OBJECTIONS to Application Number: SSD 8669
Applicant: St Aloysius' College Limited

14 August 2019

OBJECTIONS to view obstructions from the proposed new development plans at St Aloysius.

Application Number SSD-8669

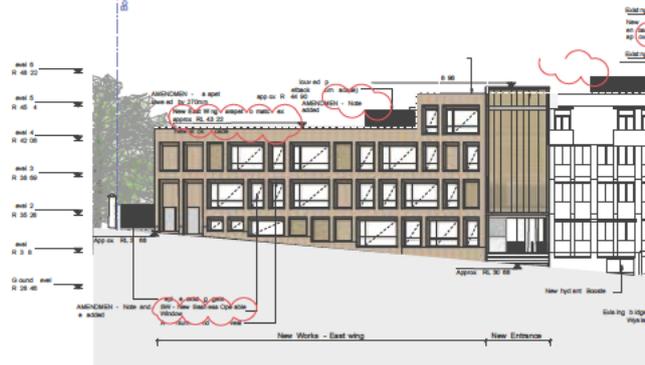
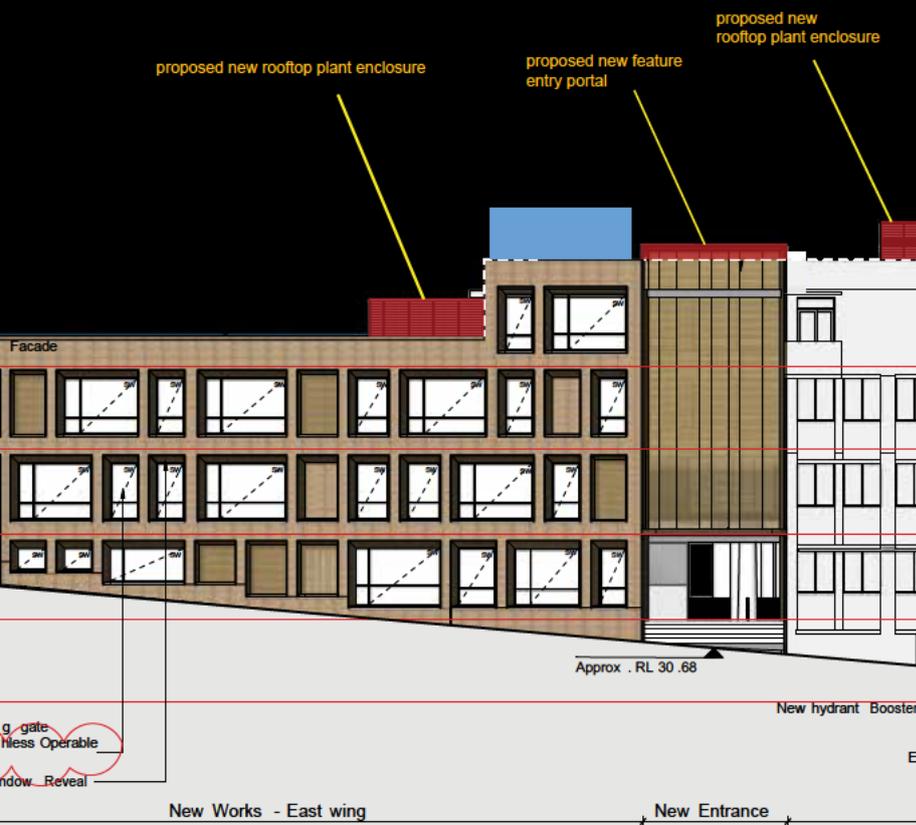
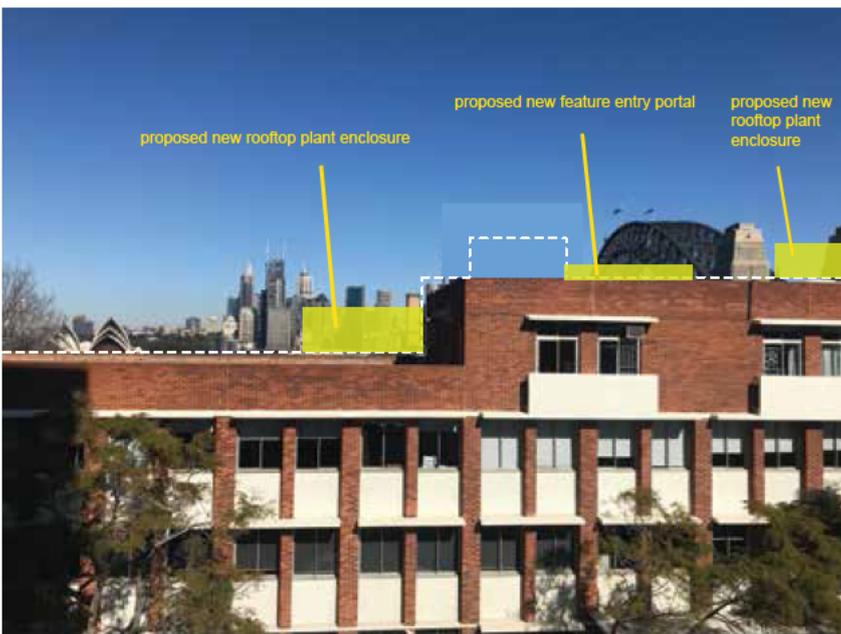
Based on the plans available on the website, these are guides using overlaid proportions of our existing view, and the plans made public; the yellow and red blockages denote possible view obstructions, given the plans are front on, and exact measurements are not provided (ie., a greater obstruction would potentially occur if the plans are inaccurate and the plant enclosure for example, is bigger than indicated). Nonetheless, which ever way you look at it from our living areas, there are **SIGNIFICANT (not 'negligible' or 'minor' as mentioned in the visual assessment report, view losses from our main, dining and kitchen areas, thus chopping up our iconic and valued views of Sydney.**

ie., The images provided in the Visual Assessment Report have been taken from an angle that doesn't show the existing valued views of Sydney cityscape and Circular Quay and the true obstruction to iconic views from the living, dining and kitchen areas. We believe the Plant enclosures should be contained within the new expansive areas of the new development, without adding height to the existing building's envelope. We ask that the feature entry portal should also not be built higher than the existing structure height, as this it seems is necessary.

1 North Elevation - Upper Pitt Street
Scale: 1:200

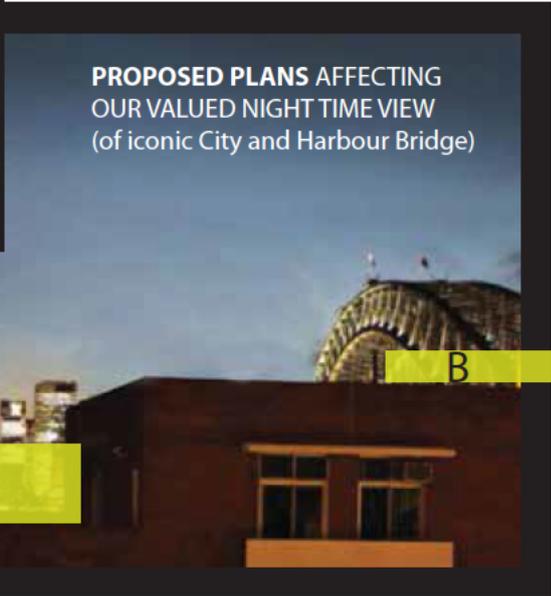
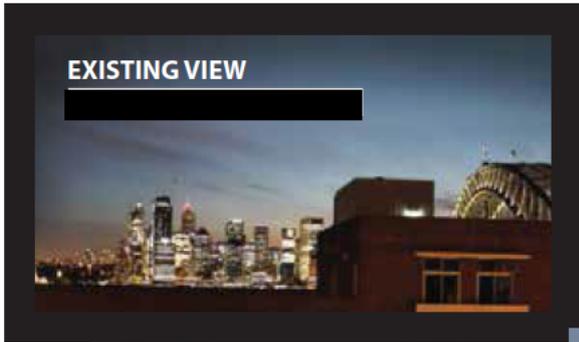
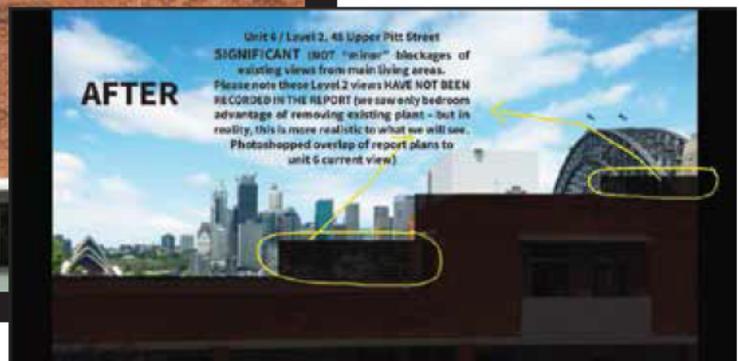
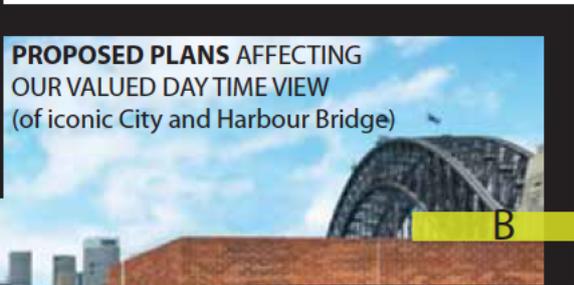
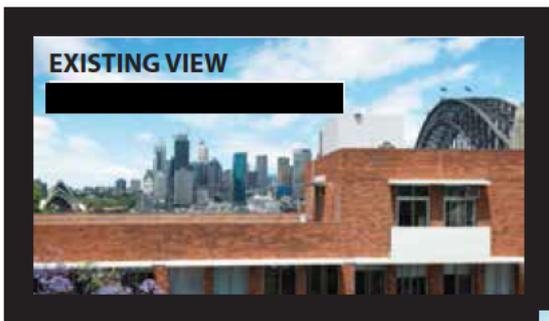
Yellow zones indicate guide (based on overlay of plans provided, although they do not specify accurate dimensions which means even greater concern if they are planned to be even bigger than that depicted! ****) to proposed new:

A: PLANT ENCLOSURE ON NORTH-EAST WING and

B: Feature Entry Portal.

Please note the 2nd of 3 Plant Enclosures will also block some view, but is not included in this picture.

We strongly urge to ensure no height be added to the existing building envelope, and the plant enclosures (paricularly on the Noth-East wing) be enclosed WITHIN the new and expansive buildings. Our iconic views are valued and should be protected.

1. Reducing the height of the proposed feature entrance portal to the existing building's height.
2. Locating the plant enclosure within the proposed new building, without adding obstruction and height to the existing height envelope. Why not incorporate this into the basement or added room of the newly built structure/wing, rather than adding it to the existing building height?

EXISTING VIEW

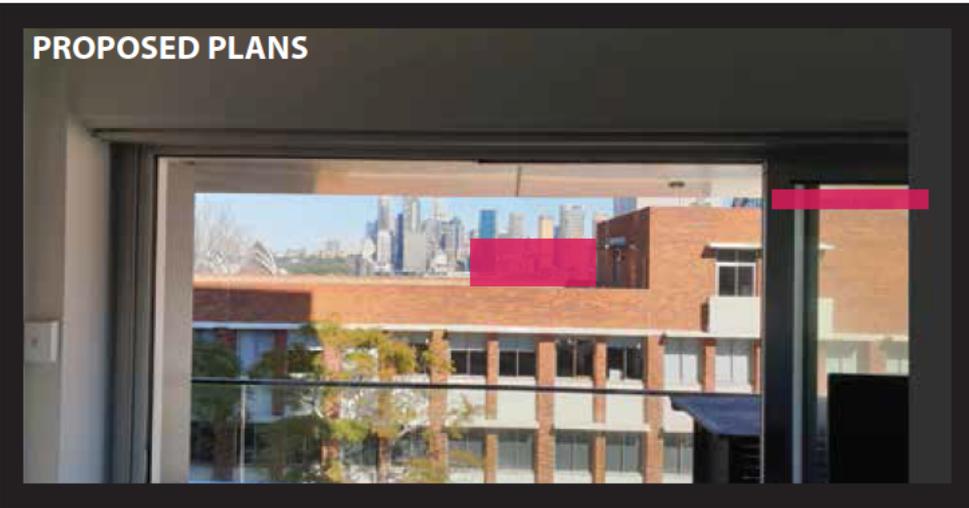
Further images illustrating obstructions to existing views from our main living area (based on proposed development plans).
